## REMARKS

APPLN. NO. 09/720,525 AMDT. DATED NOV. 5, 2004 REPLY TO OFFICE ACTION OF NOV. 5, 2003 ANNOTATED SHEET SHOWING CHANGES

Fig. 17

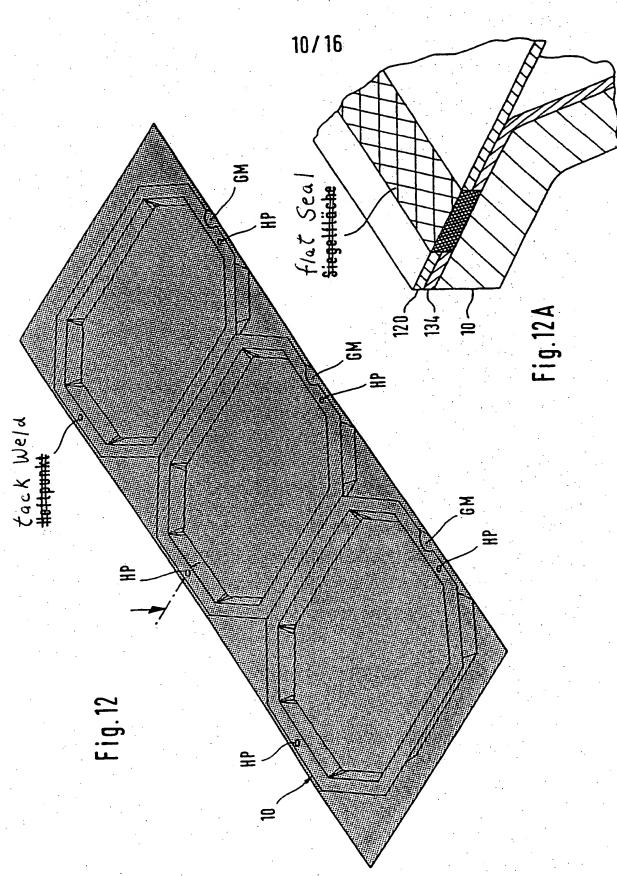
Chazal et al discloses two methods of assembling a container. In the method of FIGS. 17-21, the container flange and sidewall and the container bottom are simultaneously bent and assembled in a common mold.
